Special Bulletin

SP21-310

INTERFERENCE BETWEEN THE WIPER ARM AND THE WIPER BLADE

Prevost vehicles

Figure 1

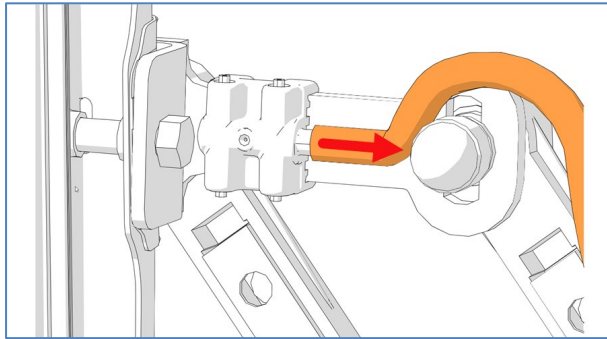
1. On both wiper arm assemblies, disconnect the windshield washer fluid hoses from the nozzles.

Figure 3

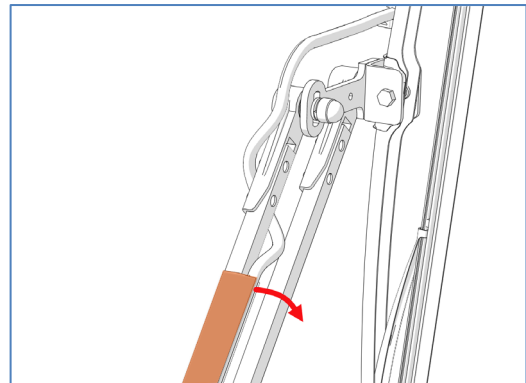
2. On both wiper arm assemblies, detach the hose holder. Take care not to damage the wiper arm paint.

Figure 4 : AS SEEN FROM INSIDE

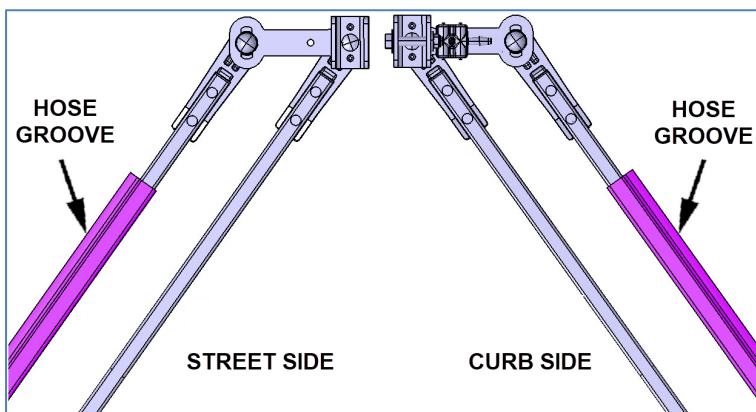
3. Reinstall the hose holder so that the hose groove is located as follows:
 - On the street side wiper arm assembly, the hose groove is located on the street side of the arm (Figure 4).
 - On the curb side wiper arm assembly, the hose groove is located on the curb side of the arm (Figure 4).
